PRODUCT CHANGE NOTIFICATION (PCN)

A-USB-APFS-x USB cable

CHANGE NOTIFICATION: PCN 20240705_A-USB-APFS-x

A-USB-APFS-x
DOCUMENT: DRAWING

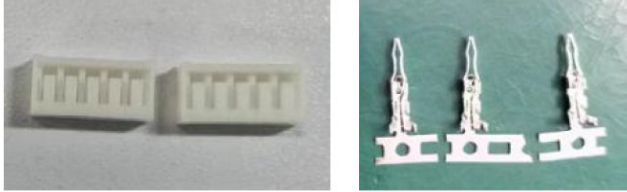
DESCRIPTION OF CHANGES: CHANGE OF PRODUCT MATERIALS
New Draw.-ASS_1576_CArev12

ASSMANN WSW P/N	Drawing Number		ASSMANN WSW P/N	Drawing Number
A-USB-APFS-x	ASS_1576_CArev11	↔	A-USB-APFS-x	ASS_1576_CArev12

A-USB-APFS-x	OLD VERSION	A-USB-APFS-x	NEW VERSION																
1. Manufacturer: JWT		1. Manufacturer: CJT																	
	<table border="1"> <tr> <td></td> <td>TERMINAL:PHOSPHOR BRONZE. TIN-PLATED JWT:B2512TOP-2</td> <td>5</td> <td>PCS</td> </tr> <tr> <td></td> <td>HOUSING: PH2.5MM 5PIN JWT:B2512H00-05P</td> <td>1</td> <td>PCS</td> </tr> </table>		TERMINAL:PHOSPHOR BRONZE. TIN-PLATED JWT:B2512TOP-2	5	PCS		HOUSING: PH2.5MM 5PIN JWT:B2512H00-05P	1	PCS		<table border="1"> <tr> <td></td> <td>TERMINAL:PHOSPHOR BRONZE. TIN-PLATED CJT:B2512-T </td> <td>5</td> <td>PCS</td> </tr> <tr> <td></td> <td>HOUSING: PH2.5MM 5PIN CJT:B2512H-5P </td> <td>1</td> <td>PCS</td> </tr> </table>		TERMINAL:PHOSPHOR BRONZE. TIN-PLATED CJT:B2512-T	5	PCS		HOUSING: PH2.5MM 5PIN CJT:B2512H-5P	1	PCS
	TERMINAL:PHOSPHOR BRONZE. TIN-PLATED JWT:B2512TOP-2	5	PCS																
	HOUSING: PH2.5MM 5PIN JWT:B2512H00-05P	1	PCS

TERMINAL:PHOSPHOR BRONZE. TIN-PLATED CJT:B2512-T	5	PCS																
	HOUSING: PH2.5MM 5PIN CJT:B2512H-5P	1	PCS
